**Staff Report**  
**City of Richmond, Virginia**

**Commission of Architectural Review**

7. COA-139550-2023	Conceptual Review <span style="float: right;">Meeting Date: 12/19/2023</span>
Applicant/Petitioner	Stanislav Lobkov
Project Description	Construct two single family attached dwellings.
Project Location	
Address: 2316-2318 Burton Street	
Historic District: Union Hill	
<p><b>High-Level Details:</b></p> <p>The applicant proposes to construct two attached dwellings on two vacant lots. The dwellings will be attached to the west elevation of an existing two-story frame Italianate dwelling.</p> <p>Historically, 2316-2318 Burton Street were the two end units of 2320-2326 Burton Street. These units were demolished sometime in the late 1970s or early 1980s.</p> <p>The proposed new construction will be identical in design to the existing 2320-2326 Burton Street.</p>	
Staff Recommendation	Conceptual Review
Staff Contact	Alex Dandridge, <a href="mailto:alex.dandridge@rva.gov">alex.dandridge@rva.gov</a> , (804) 646-6569

Figure 2. 1905 Sanborn Map. Grouping of six attached, frame dwellings at 2312-2322 Burton Street (present day 2316-2326 Burton Street) can be seen at the corner of Burton and Pink Streets.

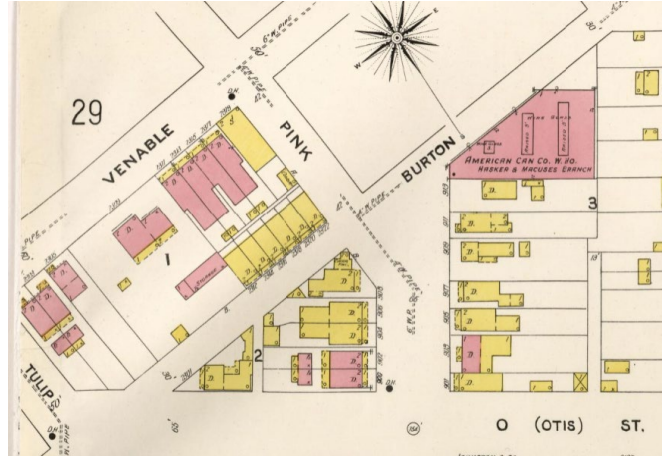
Figure 1. Assessor's Card photo showing the attached dwellings located at 2316-2326 Burton Street. The end units located at 2316-2318 Burton Street, the subject parcel's buildings were demolished sometime in the late 1970's or early 1980's.
